Architectural Review Committee Staff Report

Meeting Date: July 2, 2025

PETITIONER: Taylor Morrison

PETITION: Product Architectural Change Recommendation

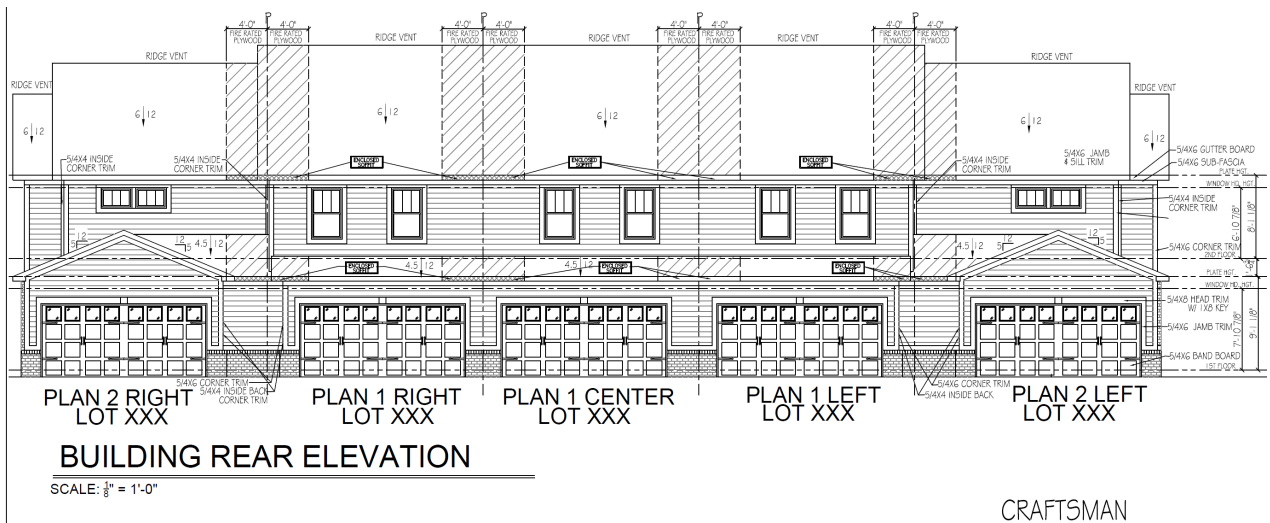
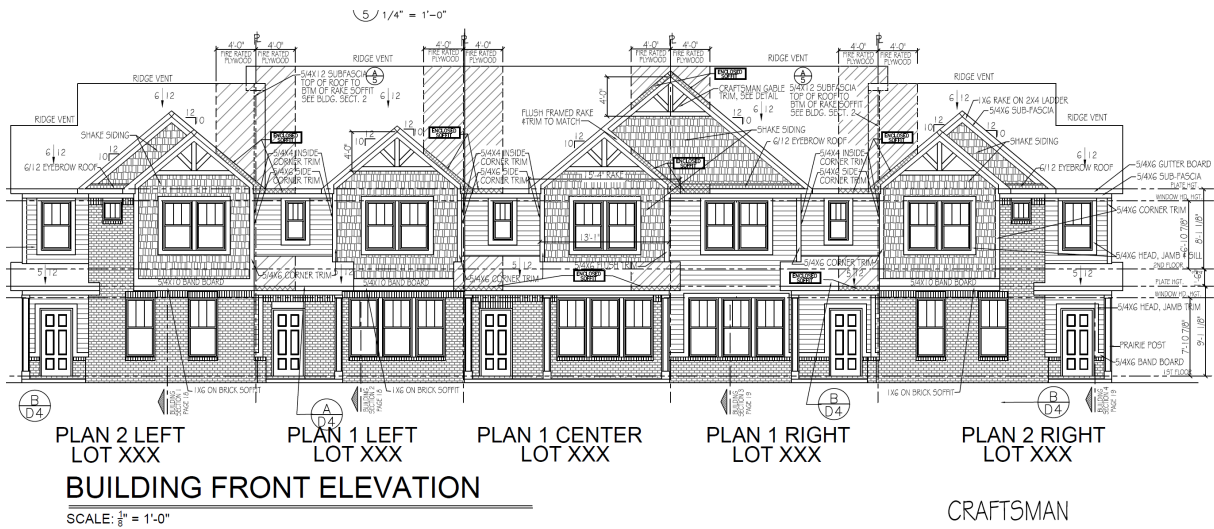
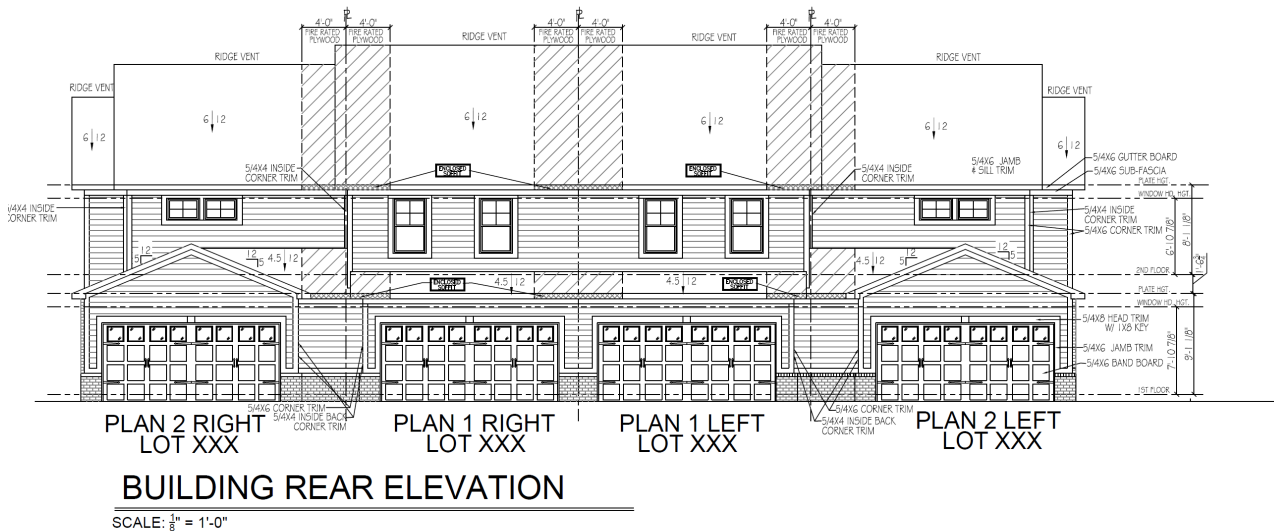
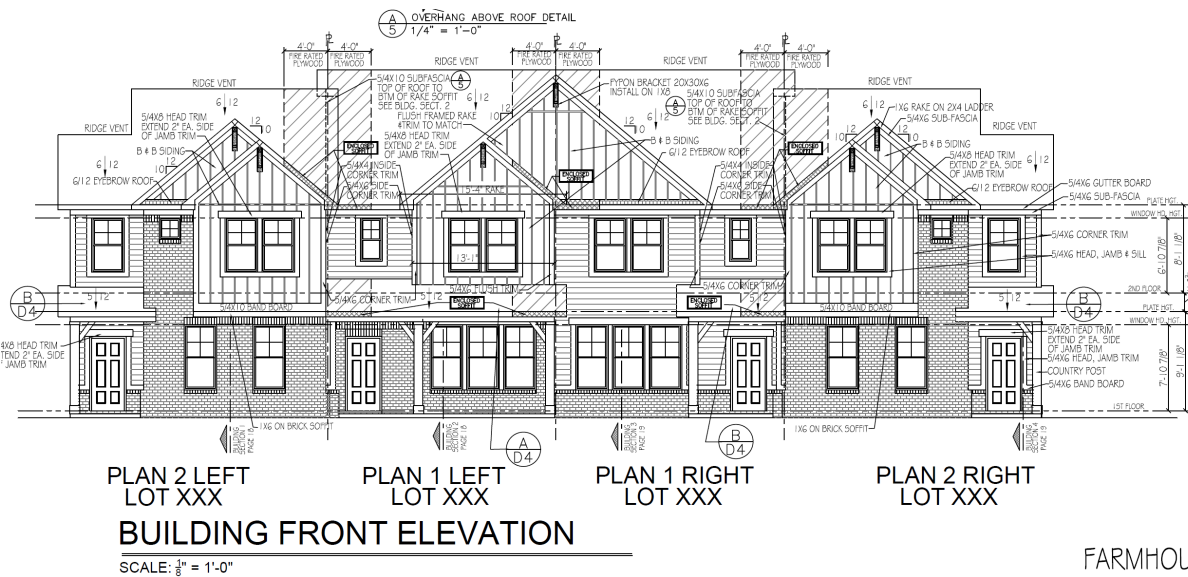
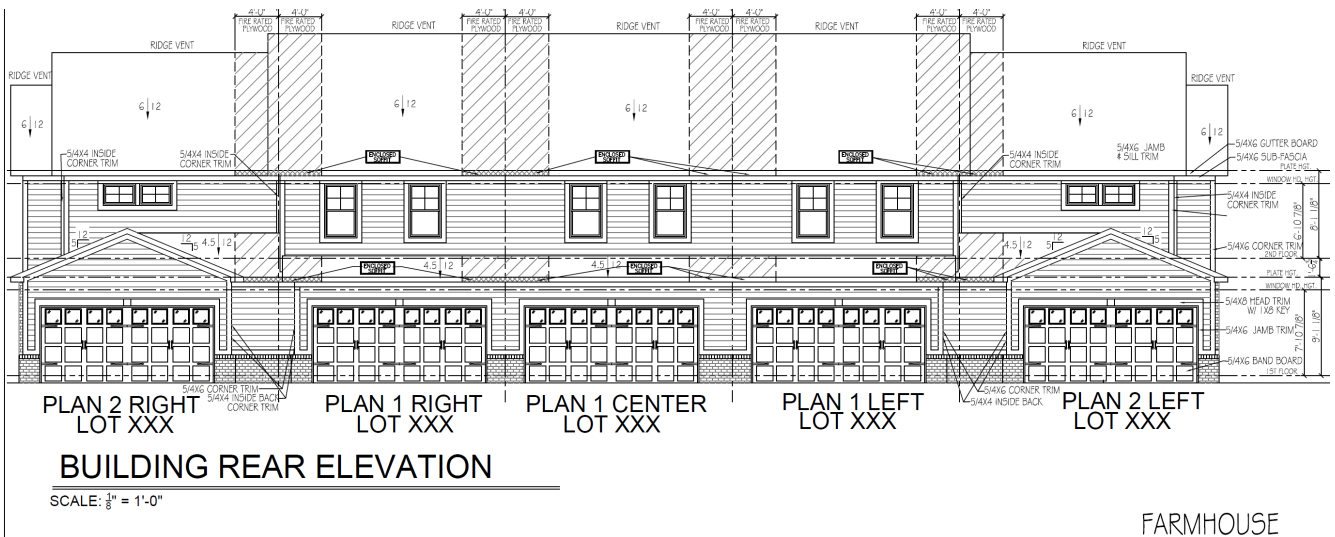
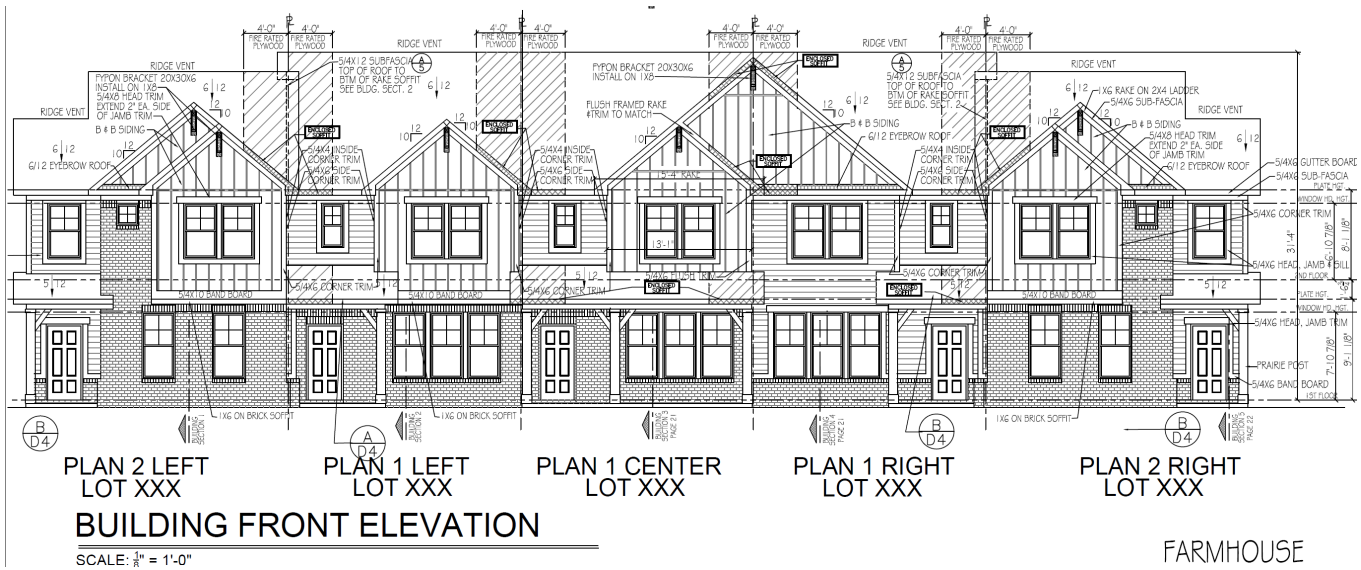
- **Brick Requirement:** The front elevations do not appear to meet the PUD's 50% brick requirement. However, the ARC may approve

alternative treatments if they are found to be architecturally consistent with the overall style.

- **Rear Window Requirement:** The rear elevations do not appear to meet the PUD requirement of three windows per unit.
